Subject: Peach Bottom Atomic Power Station, Units 2 and 3  
Change to the Technical Specifications Bases  
Regarding the Power/Flow Map

The purpose of this letter is to inform you of a change to the Peach Bottom Atomic Power Station (PBAPS), Units 2 and 3 Technical Specifications (TS) Bases, Figure 1.1-1, "APRM Flow Bias Scram Relationship to Normal Operating Conditions." This change is being implemented in accordance with 10 CFR 50.59.

Figure 1.1-1

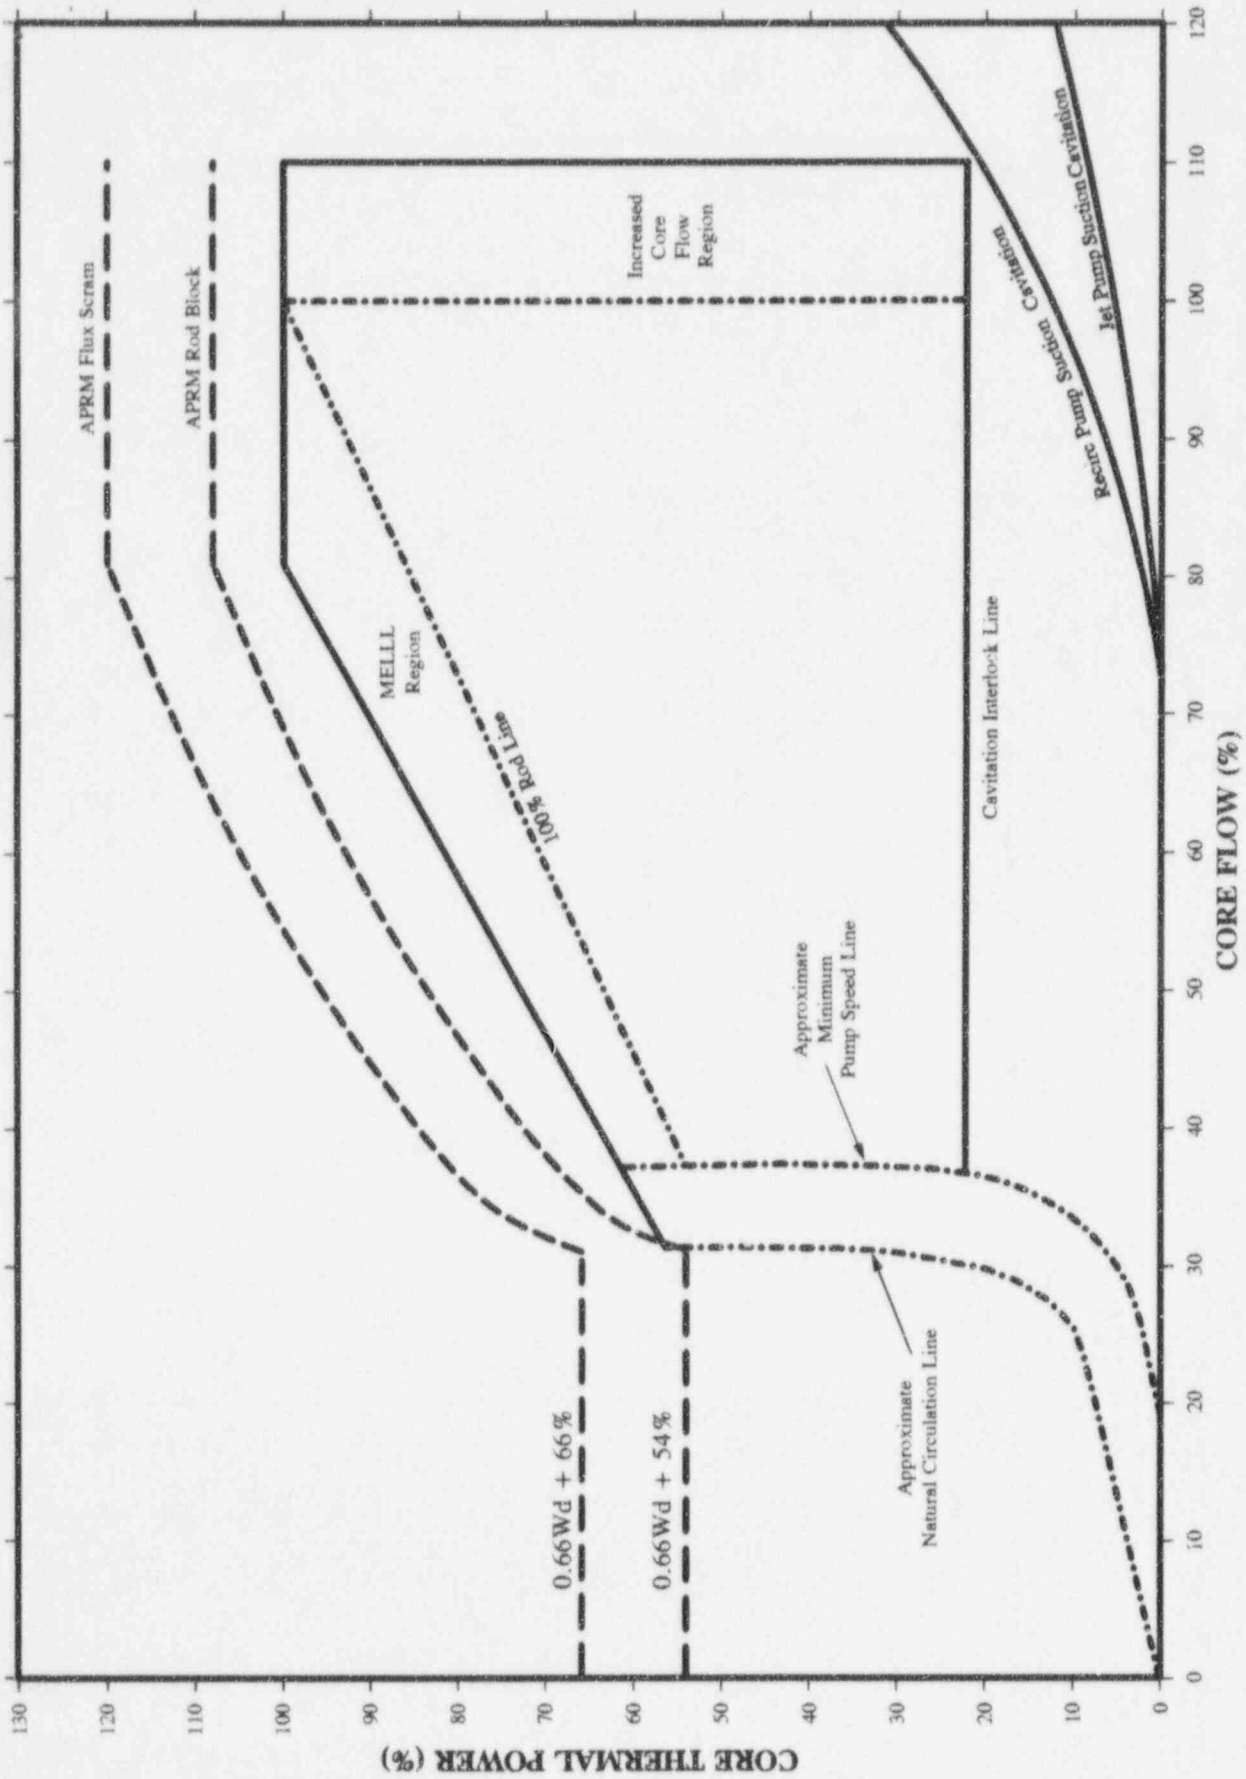
The purpose of this change is to allow a maximum core flow of 110% of rated flow from 100% rated thermal power to the cavitation interlock line as shown in the revised Bases Figure 1.1-1 for both units (Attachment 1). This change will allow PBAPS, Units 2 and 3 to maximize generation throughout the entire fuel cycle. This change has been incorporated utilizing appropriate GE Nuclear Energy analyses. The PBAPS, Unit 2 Figure 1.1-1 is currently being implemented. The PBAPS, Unit 3 Figure 1.1-1 will be implemented in association with Amendment No. 211 concerning power rerate.
